LIVSEY & COMPANY, INC.
INDIANA & MICHIGAN ELECTRIC CO.
DONALD C. COOK NUCLEAR PLANT

DWN. SG DATE 12-3-71 AUXILIARY BLDG
CKD. GN DATE 1-6-72
ISSUED
REF. DWG. 2-5497
DWG. NO. 2-NSW-102 SH. 2 OF 2
REV. 8

2NSW-102 (sheet 2 of 2)
Upper Containment Ventilation
Unit 2 Supply Line

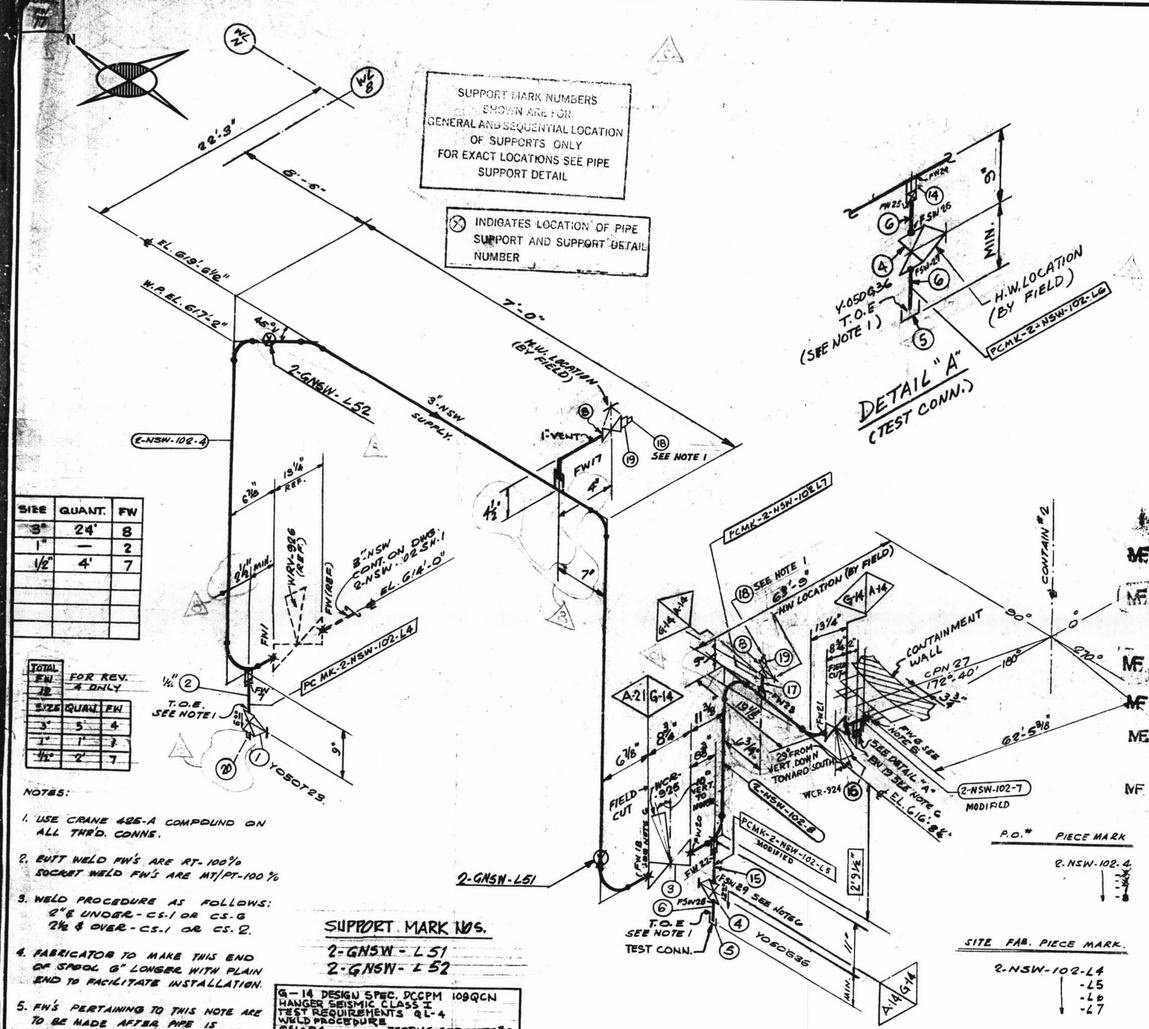
| NO. | DATE | DR. CHK | DESCRIPTION | REMARKS |
|---|---|---|---|---|
| 1 | 1-20-76 | DR. BR. | REVISED BY AEP DESIGN. PER RFC-12-671: REV'D. ITEM #4 Y-050G36 WAS CV-050G36. ADDED: 3" CHECK VA. C15CE03A (8) 1" VENT-VALVE NO Y-100T23, 1/2" DRAIN-VALVE NO Y-050G36. | ACTION REQ'D |
| 2 | 1-4-77 | W.R. | 7'-0" WAS 6'-0" | |
| 3 | 3/21/78 | GP LB | AS PER RFC-12-1430 DELETED VALVE TAG NO. C15CW03A & ITEMS 9 THRU 13 AND REVISED RELATED PIPING. | FIELD ACTION REQ'D |
| 4 | 9/18/81 | A.G. MW | AS PER RFC DC-12-2549 ADDED PIPE SPEC. G-14. DIM'S, PC MK LG, L7&8 WELD BOX, NOTES 6 & 7, FIELD WELDS 18 TO 24, FSW 25, 27 TO 29 ITEM NOS. 14 THRU 17 TO B/M DELETED ITEM 7, 9, 10, TO 13, PC MK. 5&6 FROM B/M. REV. ITEM 3 IN B/M. MODIFIED PCMK L5 & 2-NSW-102-7. | Field Action Req'd. |
| 5 | 10/14/81 | KA LB | PER RFC DC-12-2549 ROTATED ACTUATOR OF VALVE WCR-925 TO 10" VERT. TOWARD NORTH AND ACTUATOR OF VALVE WCR-926 TO 25" VERT DN. TO SOUTH. ADDED DIM. 8" | FIELD ACTION REQ'D |
| 6 | 6/4/82 | SG LB | PER RFC-DC-12-2549 BOXED DIMENSION INDICATES FIELD INFO. DELETED 8 EL. G14'-0" & ADDED PLUG TO ITEM. 8 & B/M. | FIELD ACTION REQ'D |
| 7 | 11/16/84 | WT. JHK | PER RFC-DC-12-2549 ADDED REQ. INSERT & PLUG TO VALVE, ITEM 8. ITEM 8 WAS Y-100T23 & ITEM 19 WAS 1". | FIELD ACTION REQ'D. |
| 8 | 7/12/86 | ESG DRM LB | TO REFLECT AS-FOUND CONDITIONS FOR RFC-DC-12-3010 PER FWR # 759 REV. 1; ADDED: 1/2" PLUG DIM'S. & ITEM NO. 20 ON B/M; ADDED: SUPPORT MARK NOS. & SUPERSEDES HGR. 150 # 2-GNSW-102 SH. 2 | NO FIELD ACTION REQ'D. |
